Re: Florida Power & Light Company
Proposed Turkey Point Units 6 and 7
Docket Nos. 52-040 and 52-041
Response to NRC Request for Additional Information Letter No. 037
(eRAI 5896) SRP Section - 02.05.02 Vibratory Ground Motion

NRC RAI Letter No. PTN-RAI-LTR-037

SRP Section: 02.05.02 - Vibratory Ground Motion

NRC RAI Number: 02.05.02-2 (eRAI 5896)

Figure 6c: EPR1 (FSAR Reference 242) Mid Continent 1Hz weighted mean attenuation curve for a magnitude 8 earthquake.

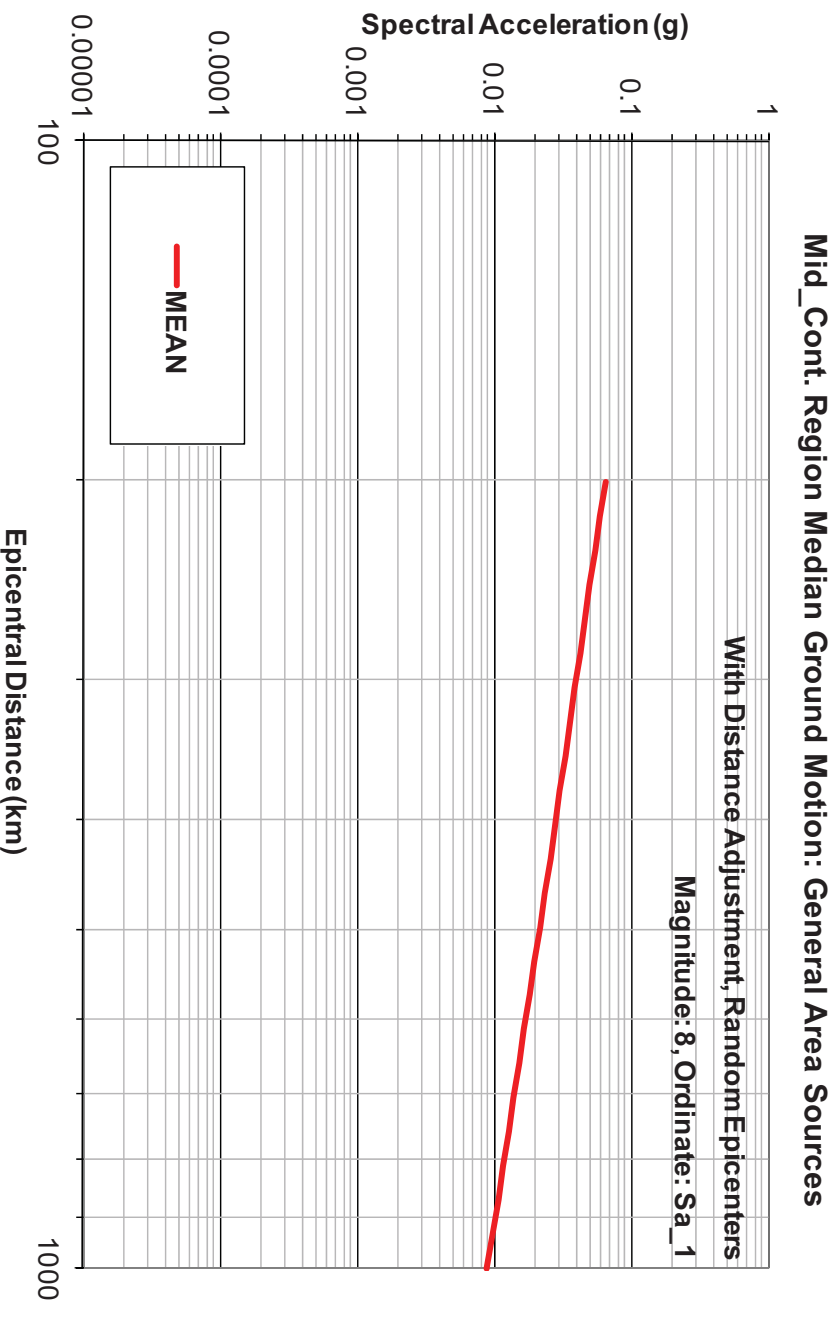
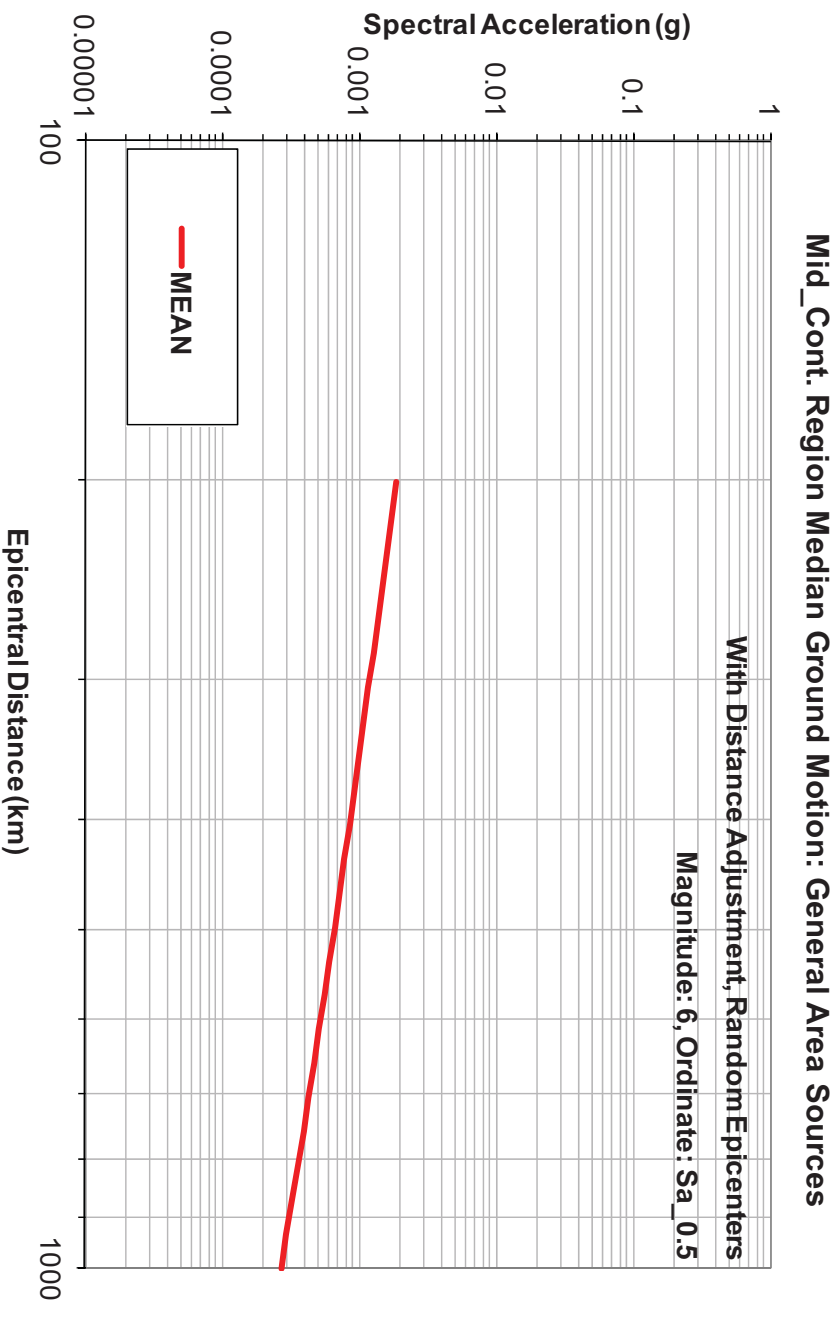
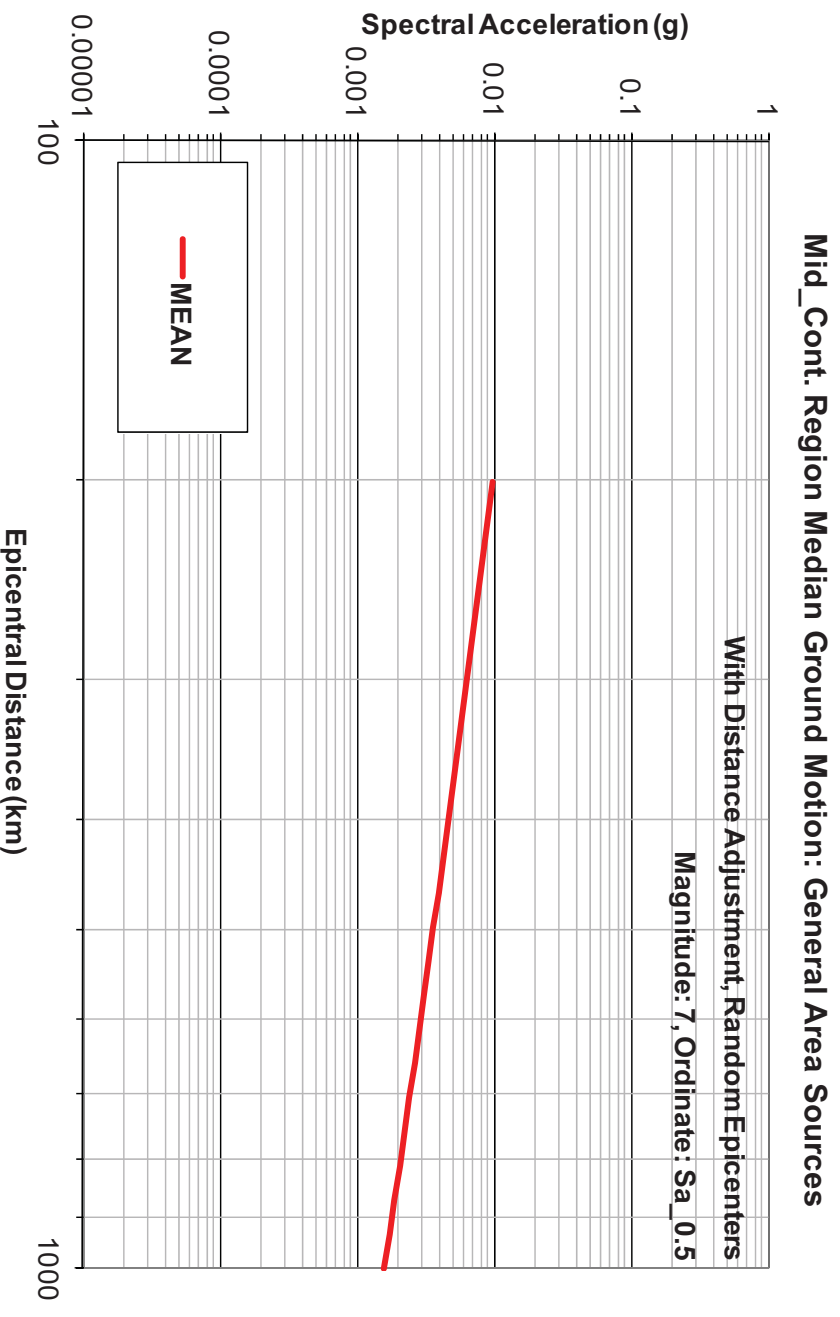
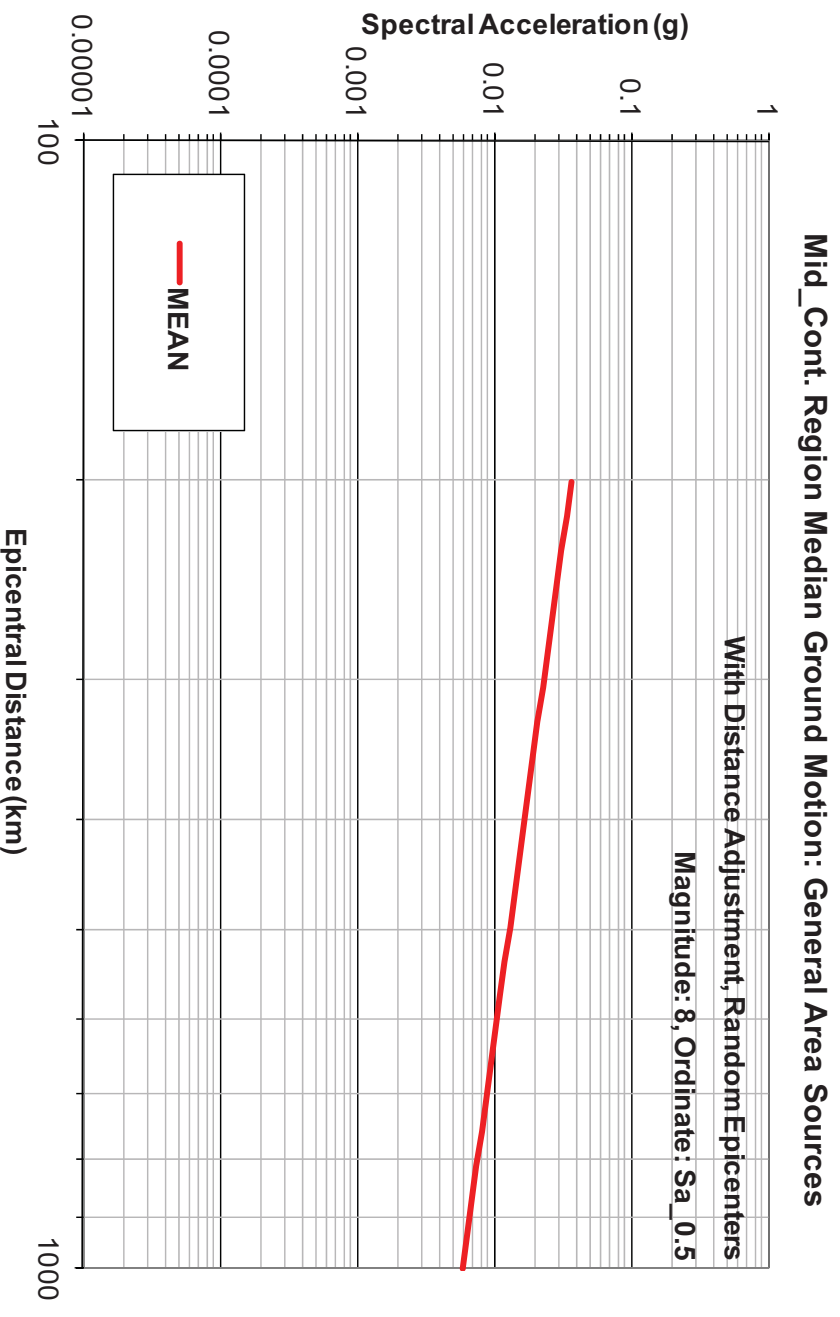
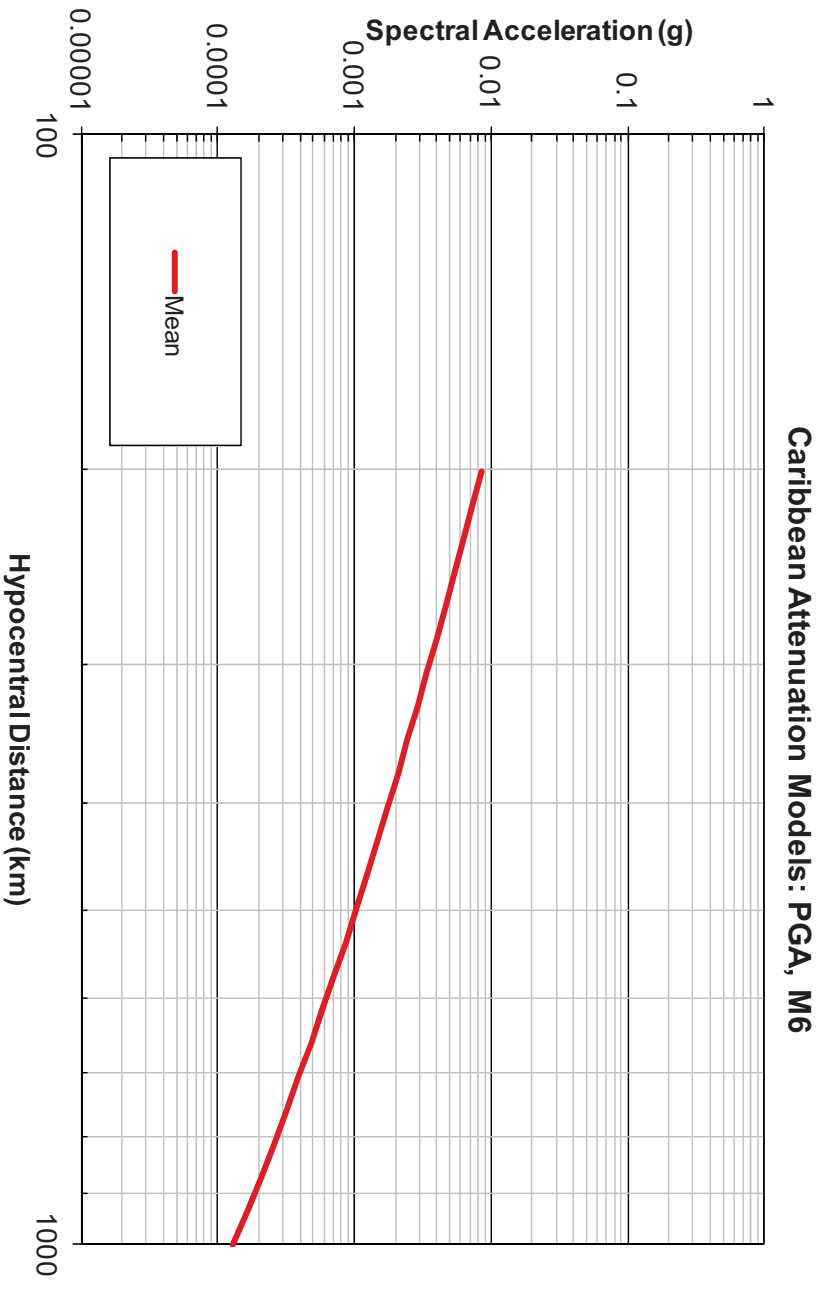
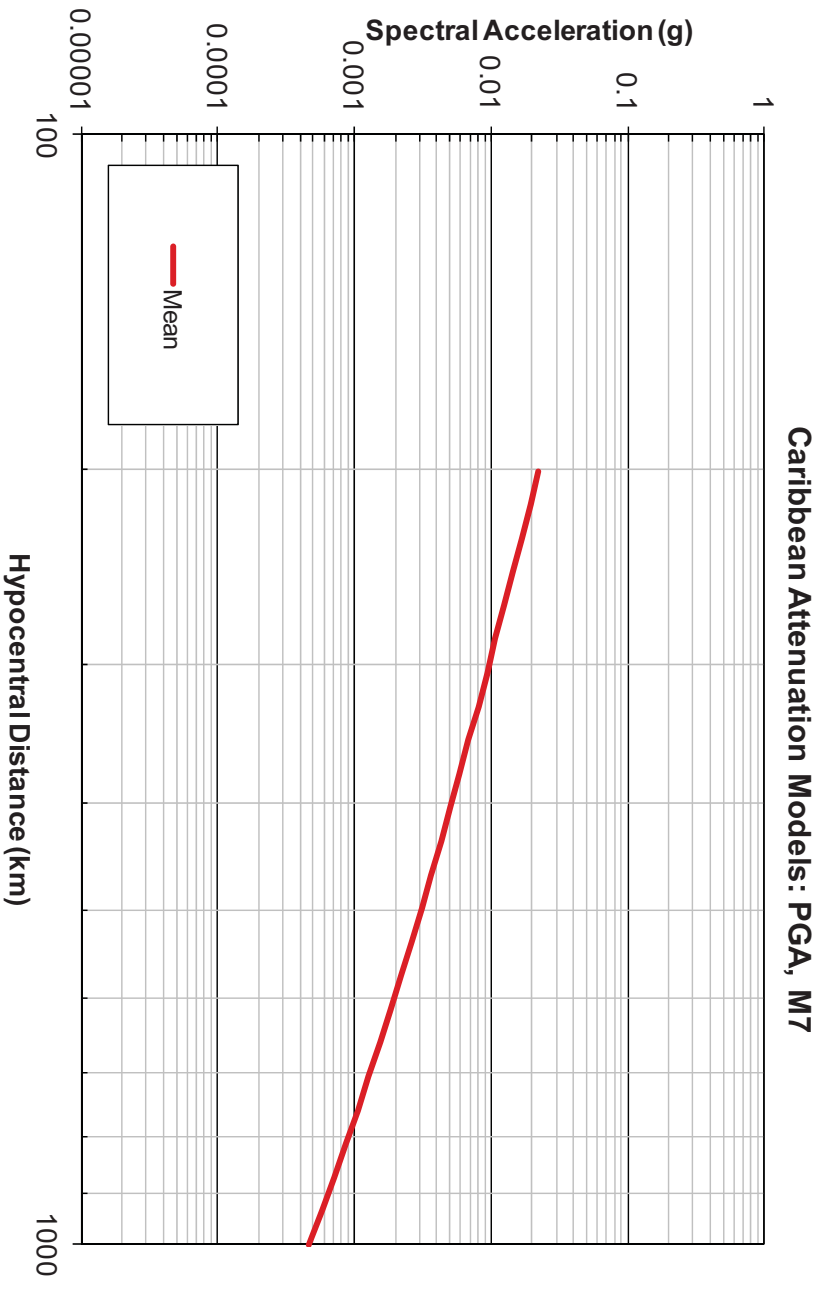
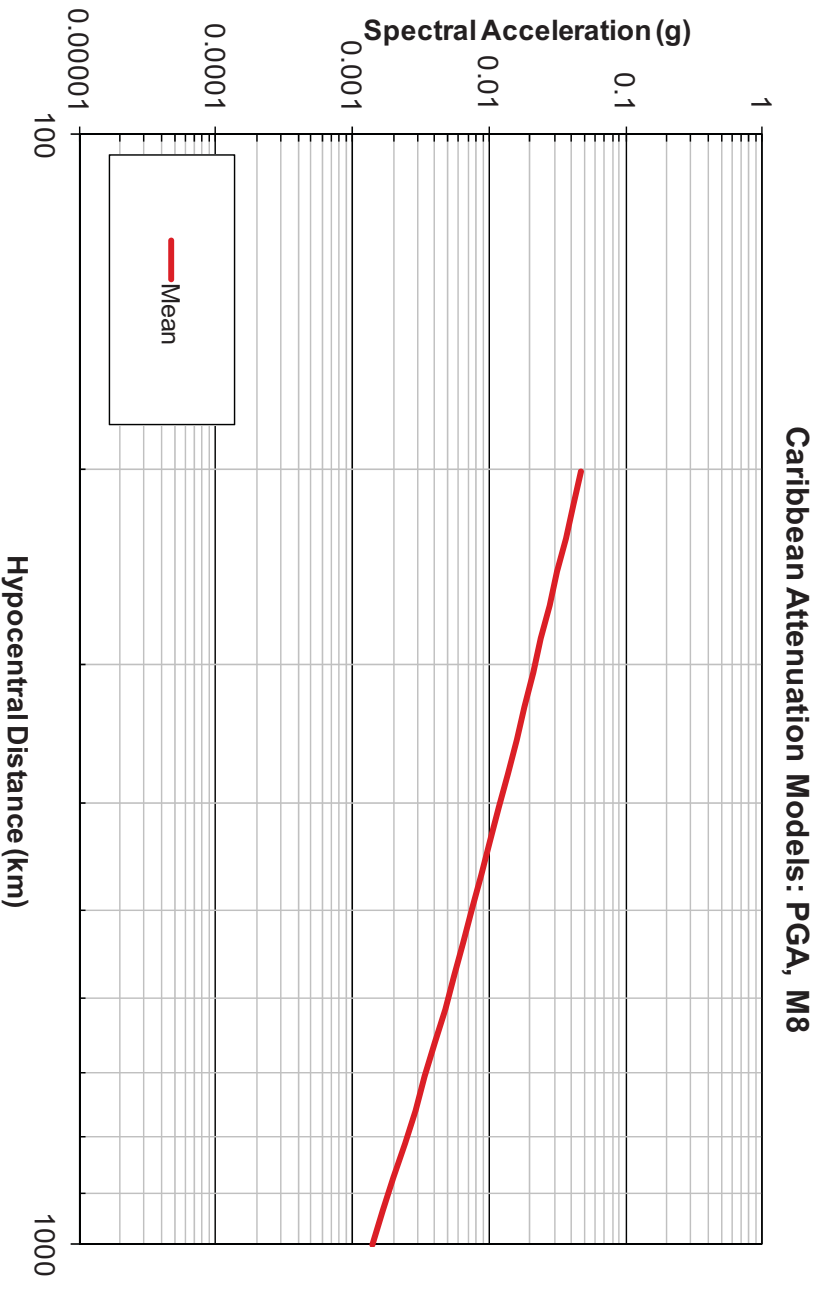
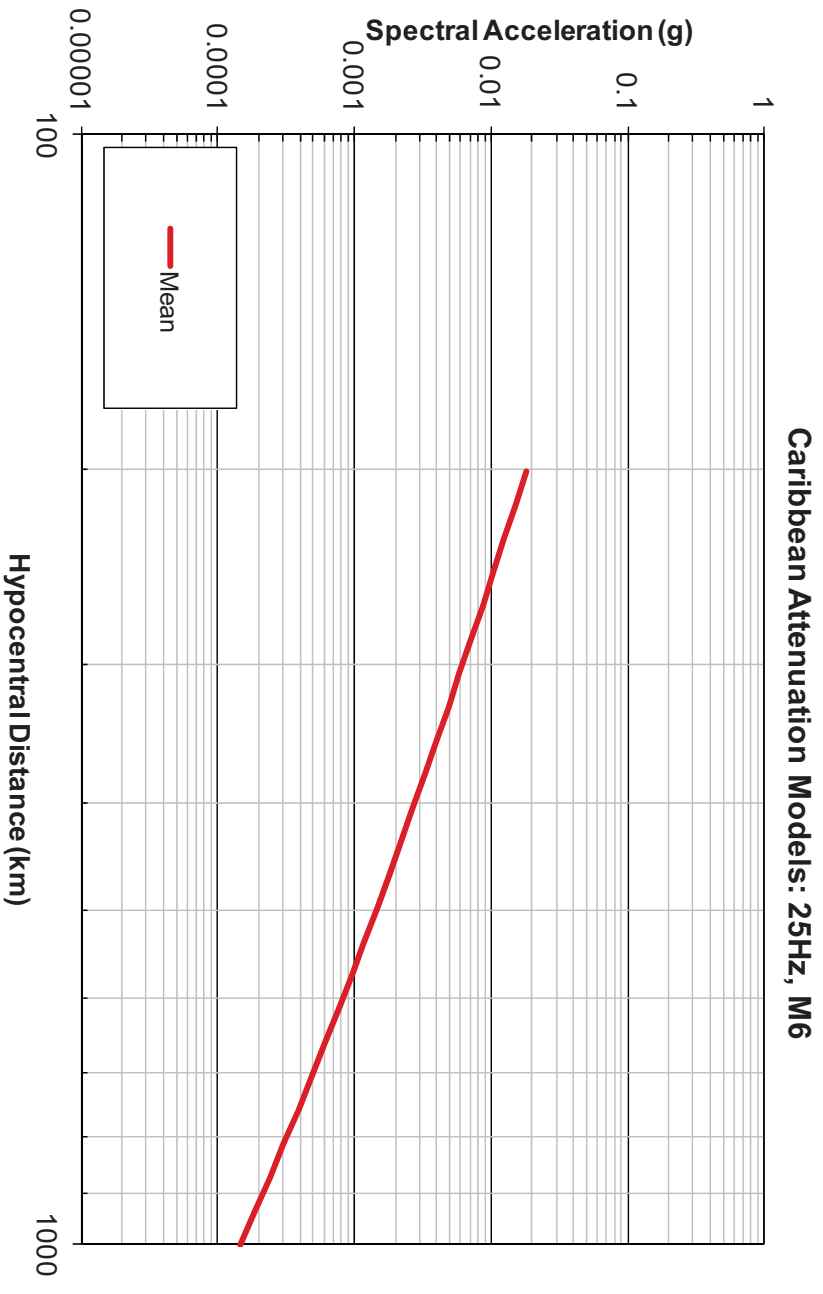
- d. In order for the staff to be able to compare the new Caribbean GMPEs with the 2004/2006 EPRI mid-continent GMPEs, please provide plots showing both ground motion models for earthquake magnitudes of 6.0, 7.0, and 8.0 in the distance range of 200 km to 1000 km at all seven frequencies defined in the EPRI 2004 and 2006 GMPEs.

Ground motion attenuation curve plots are provided for the EPRI (FSAR References 242 and 203) and Caribbean ground motion prediction equations (GMPEs). Note that EPRI (FSAR Reference 203) is only a recommendation for the associated aleatory uncertainty and therefore does not impact the comparison plots of the weighted mean ground motion

attenuation curve. The plotted mean attenuation curve is the weighted mean of the individual median attenuation curves as defined in EPRI (FSAR Reference 242). These attenuation plots are provided for three specific moment magnitude (M_w) values: 6, 7, and 8 for distances between 200 km and 1,000 km. Note that the EPRI (FSAR Reference 242) ground motion attenuation model is defined as a function of epicentral distance, whereas the Caribbean ground motion attenuation model is defined as a function of hypocentral distance. However, because the closest distance is 200 km, the difference between the epicentral and hypocentral distances would be less than 1% for a typical crustal depth of 10 km and even smaller for larger distances out to 1,000 km.

The weighted mean ground motion attenuation curves for the EPRI (FSAR Reference 242) model are given in Figures 1 through 7 for the three magnitudes and seven spectral frequencies requested in the RAI. The weighted mean Caribbean ground motion attenuation curve plots for the same suite of magnitudes, distances, and spectral frequencies are shown in Figures 8 through 14.
